PRODUCT SAFETY

ADVISORY

May 22, 2014

Tire Changer Clamping Adaptors

Images of listed Tire Changer Clamping Adaptors. Check circled fasteners for proper torque (16 lb-ft).

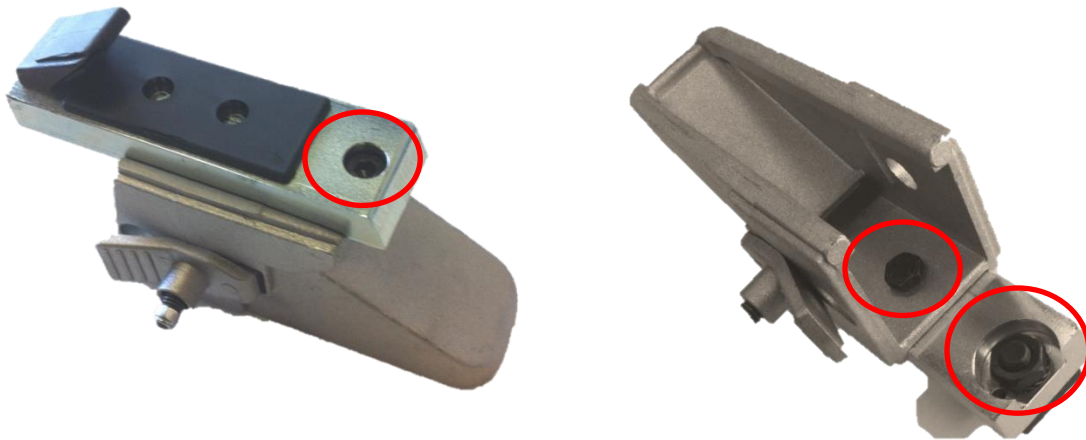
There is a potential of missing fastener(s) that can contribute to jaw failure that may cause property damage or personal injury.

1. Inspect each of the adaptors at the customer's location.
2. Determine if both bolts are present per the below images:
 - If one or both bolts are **not** present obtain the entire set from the customer and return the entire adaptor set to Snap-on Equipment with a copy of this advisory. Call 800-225-5786 to obtain the replacement set for the customer.
 - If bolts are present check that the torque is a minimum of 16 lb-ft.
3. Inspect the adaptors for cracking, misalignment or any other visible damage.
